Re: 847/851 Pine St. Howard Center (11-0618CA/MA)

At your request, and on behalf of the Howard Center, we are requesting the opportunity to attend the next available Conservation Commission hearing with regard to the project located at 847/851 Pine Street. As we have discussed, changes occurred since approval and during construction, related to the sewer connection and the extent of disturbance along the Englesby Brook bank, which are not consistent with the approved plans. The following is a summary of events that lead to the changes.

Figures showing the permitted plan and revised plan, both with actual disturbed area shown (dashed outline):

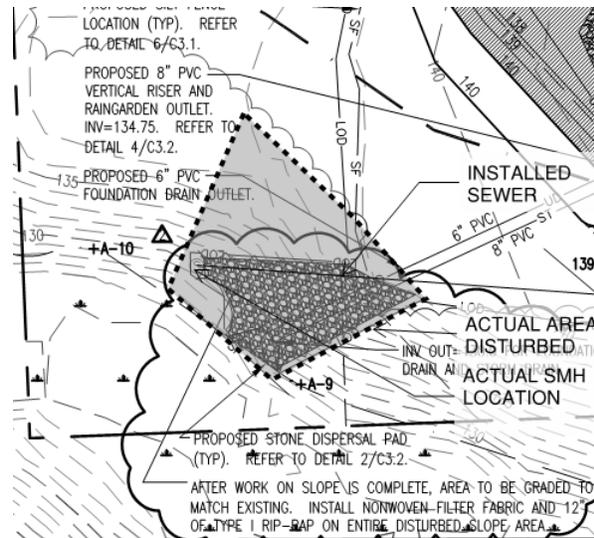
The original permitted plan indicated the proposed sewer and stormwater pipes parallel to each other, within a narrow limit of disturbance (LOD). The sewer pipe was originally intended to serve only the new building and discharged to an assumed location of the existing sewer manhole (SMH), based on City sewer mapping. The SMH was buried with several feet of soil, and was not accurately located until construction began.

As construction was beginning a few things occurred which led to the changes in the sewer line routing and corresponding extents of disturbance along Englesby Brook.

1. The existing sewer line for 847 South Pine St (the existing house) backed up prior to construction. This had been a re-occurring issue related to the poor condition of the city sewer within the Englesby Ravine, and had required repeated excavation within the Englesby Ravine over the years to unclog. This city sewer provided service only to 847 South Pine St. In order to abandon this problematic sewer, Steve Roy (BDPW) requested The Howard Center to re-route the 847 South Pine St sewer service to connect with the proposed sewer service and discharge into the SMH as shown in the above revised plan.

2. With the assistance of the BDPW, the existing SMH was un-earthed below a few feet of soil. It was determined that the SMH was further northwest as shown in the Revised Plan above. The combined 847 and 851 sewer service needed to run diagonally across the disturbed area to reach the actual location of the SMH, resulting in a wider swath of disturbance than originally anticipated.

4. As construction proceeded with the new sewer routing and actual SMH location, based on the depth of the sewer line and steepness of the bank, additional excavation and vegetation removal uphill of the sewer line was necessary to facilitate its construction and provide adequate contractor safety. That area is apparent in the Revised Plan as the shaded triangular area above the rip-rap hatched area.

Based on the above chain of events and the following considerations, we ask that the expanded area of disturbance be accepted without additional further mitigation. The additional considerations include:

1. The revised sewer routing was requested and reviewed by the BDPW and will result in an improved system, reducing the need for ongoing future excavation and maintenance in the Englesby Ravine.

2. The existing SMH rim was raised above the high waterline of Englesby Brook reducing the chance of discharge from one to the other and again reducing future maintenance in the Englesby Ravine.

3. All of this work was performed within the City Sewer Easement and necessitated by the sewer back-up at 847, and therefore could be considered maintenance and repair.
